AMEC Project Number VM00448

**Reference: Mt. Polley Mine Tailings Facility
Optimization Potential – Follow Up from Dam Safety Review**

**TSF Potential Optimization Workshop
February 2007**

MOUNT POLLEY MINING CORPORATION	
MOUNT POLLEY MINE	
TAILINGS STORAGE FACILITY SECTION LOCATIONS (ULTIMATE FACILITY SHOWN)	
Knight Piésold CONSULTING	PROJECT NUMBER: 181116P, 181116P, 181116P, 181116P, 181116P WA101-1/1D 19-1180 A
FIGURE 1

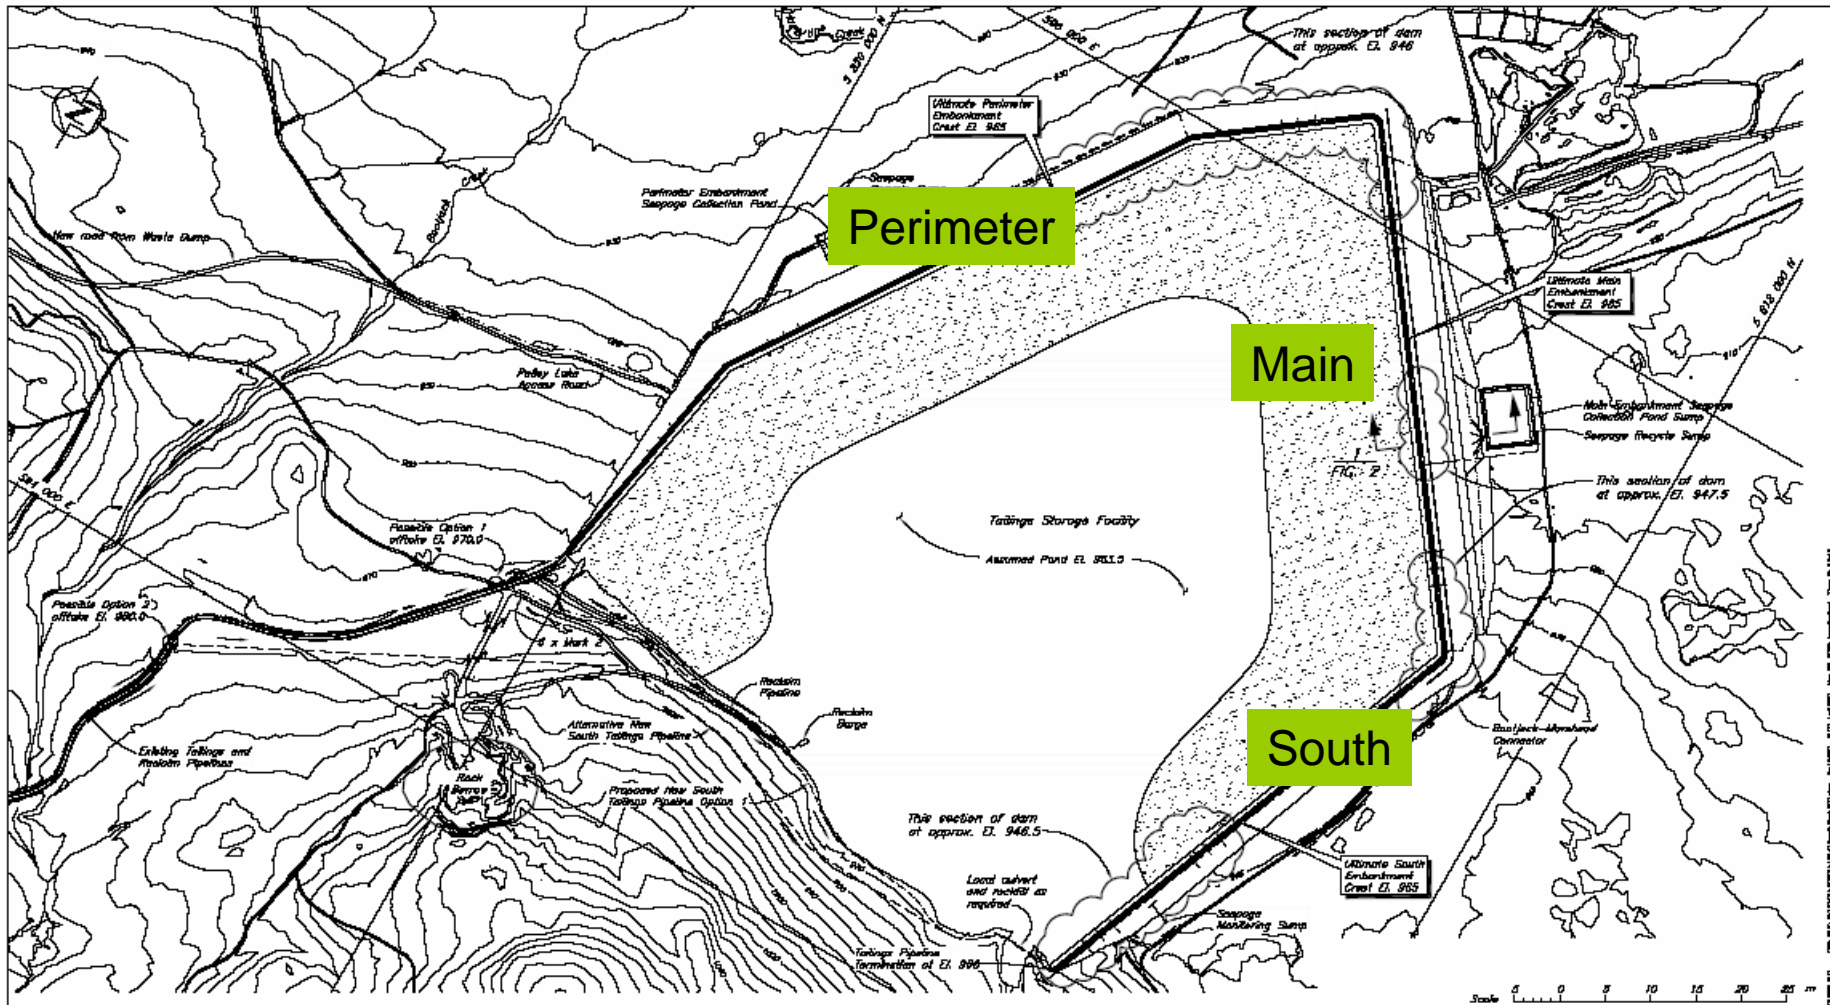
Finally, the conceptual layout in Figure 1 of the provided "Preliminary Design of the Tailings Storage Facility to its Ultimate Elevation" cannot be practically achieved. The nature of the manner in which tailings beaches develops is at odds with the schematic concept in Figure 1. A more realistic tailings planning exercise will be required prior to adopting a final closure plan for the TSF.

MOUNT POLLEY MINING CORPORATION	
MOUNT POLLEY MINE	
TAILINGS STORAGE FACILITY MAIN EMBANKMENT TYPICAL SECTION	
Knight Piésold	TRUST AGREEMENT No. 1 Rev. No. 107 VK101-1/10 105-1100 A
FIGURE 2

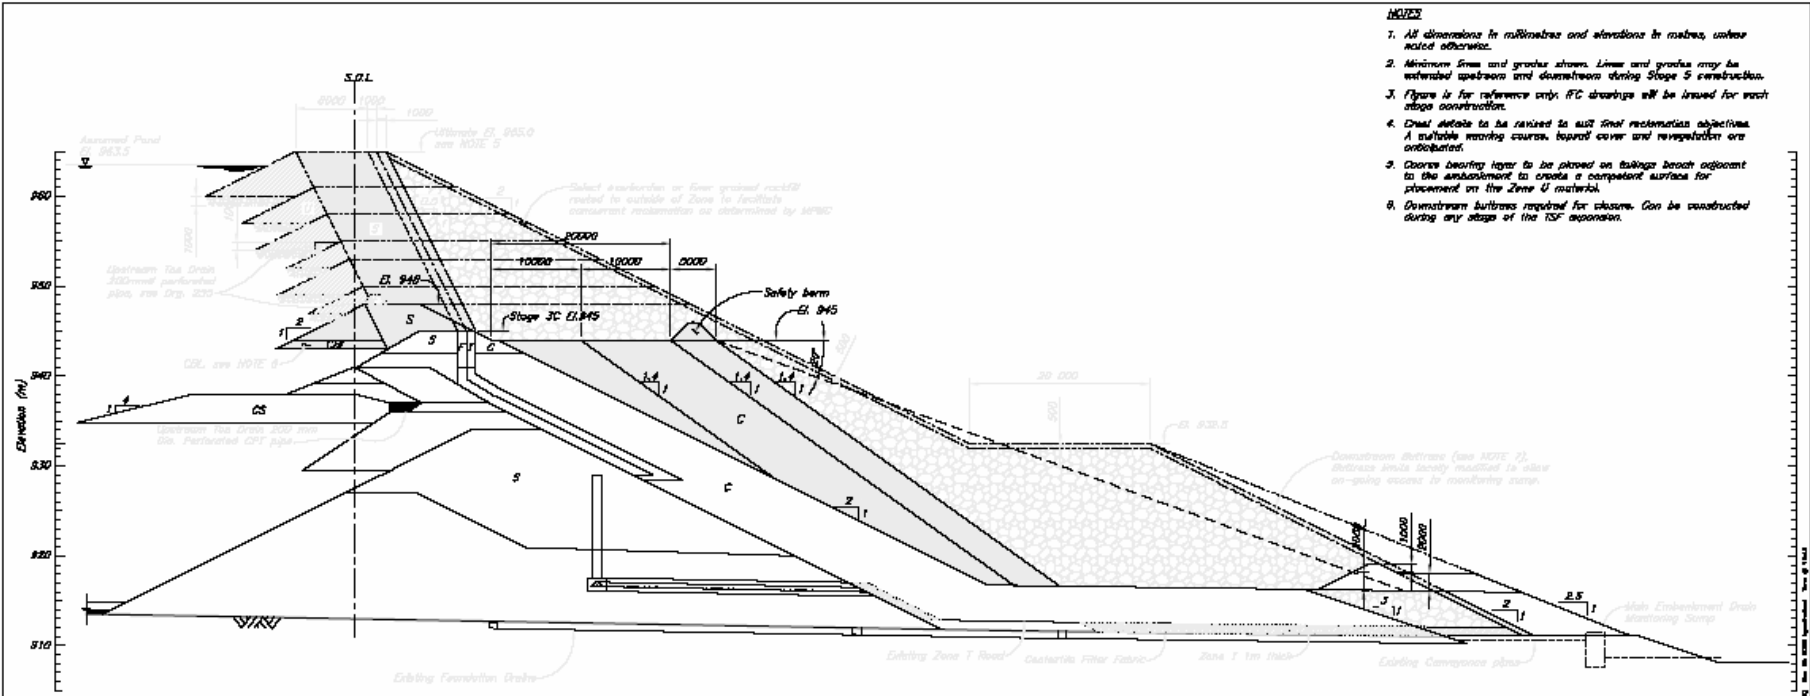
From our review we consider that there is a real opportunity to reduce the width of the core zone being stipulated for the raises moving forward. It is common dam engineering practice to narrow the core with height in the dam though there is a minimum thickness for the core (typically a practical construction consideration). The current core width of 8 m is certainly robust. Given the remaining projected height of dam construction to final elevation (assuming that the currently stipulated final elevation is not significantly exceeded), a decrease in core width should be considered for the 2007 raise and each raise thereafter. An acceptable rule of thumb is to have the core width be a minimum of 30% of the maximum head on the core; for example 20 metres of head corresponds to a 6 metre minimum requirement. The core could be further narrowed as the dam is raised in future, down to a practical minimum width of 3 m to 4 m.

Per the 2006 DSR report, it remains unclear to us why a buttressing berm has been specified for the closure geometry of the TSF. Provided that the foundation parameters are consistent with the glacial till reported in the documents to date, there should not be a foundation concern with the existing Main Embankment Dam geometry. The foundation strength parameters indicated in design documentation for the TSF to date and the current planned geometry without a berm would result in adequate stability conditions for operations and the closure condition.

The only uncertainty is the nature of the foundation soils regarding potential presheared planes of weakness. This issue was raised during the DSR but had not been noted in previous design documentation. If there is no such concern, as above, then there would appear to be no real need for the proposed berm.

Finally, if there is a valid reason for the berm identified the berm material need not necessarily be waste rock from the mine. All that would be required is an equivalent mass and, depending upon placement and geochemical considerations, even tailings may be an acceptable berm construction material.
